# UNITED STATES PATENT AND TRADEMARK OFFICE

APPLICATION NO.	FILING DATE	FIRST NAMED INVENTOR	ATTORNEY DOCKET NO.	CONFIRMATION NO.
10/070,467	07/11/2002	Martin John Charles Offa-Jones	THOM-0020	4678

## Office Action Summary

## DETAILED ACTION

FIG. 1

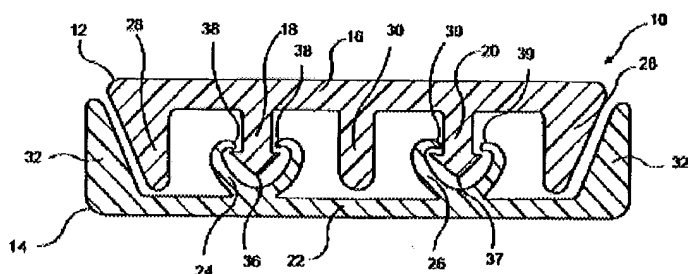
Claim 16 is rejected under 35 U.S.C. §102(e) as being clearly anticipated by Malin (US 6167597).

Malin (figure 1) teaches a reclosable fastener for bags, comprising a first element 12 comprising a first elongate body portion 16, at least one first upstanding elongate profiled member 18, 20 extending away from the first body portion, a first upstanding post comprising a wedge-shaped member 28 at a first lateral margin of the first body portion, and a first heel comprising an identically configured wedge-shaped member 28 at a second lateral margin of the first body portion; a second element 14 comprising a second elongate body portion 22, at least

one second upstanding elongate profiled member 24, 26 extending away from the second body portion, a second upstanding post comprising a wedge-shaped member 32 at a first lateral margin of the second body portion, and a second heel comprising an identically configured wedge-shaped member 32 at a second lateral margin of the second body portion; wherein the first and second profiled members are releasably engagable when the first and second elements are pressed together with the first and second profiled members facing each other in order to produce an engaged condition of the first and second elements; and wherein, in the engaged condition, both the first post and the second heel, and the second post and the first heel, are aligned and are arranged to contact each other at respective complementarily angled contact surfaces thereof to form a configuration which provides resistance to compression forces exerted on the first and second elements in their engaged condition thereby substantially preventing distortion of the first and second profiled members under application of a load urging the first and second elements together when in their engaged condition (col. 4, lines 36-61).

The high compression members function in the following manner. As one or both of the interlocked male and female profiles 12, 14 are sealed to thermoplastic film, such as by seal bars, the profiles are compressed together. This compression causes the opposing wedge-shaped high compression members 28, 32 on the male and female profiles 12, 14 to contact each other and the central high compression member 30 of the male profile to contact an inner surface 34 of the female profile base 22. The lengths of the high compression members are such that said contacts occur before the extremities 36, 37 of the male interlocking members 18, 20 contact the female profile 14, or the extremities 38, 39 of the female interlocking members 24, 26 contact the male profile 12, and thereby damage or distort the interlocking members. In addition, the high compression members are much thicker than the male and female interlocking members, thereby ensuring that the high compression members themselves do not distort during sealing or become sealed to the opposing profile.

In this manner the high compression members prevent distortion and crushing of the interlocking members and enable the profiles to be sealed to thermoplastic film across the widths of their bases. In the absence of the high compression members the interlocking members would be distorted and/or crushed by the heater bars, rendering the zipper strip unusable.
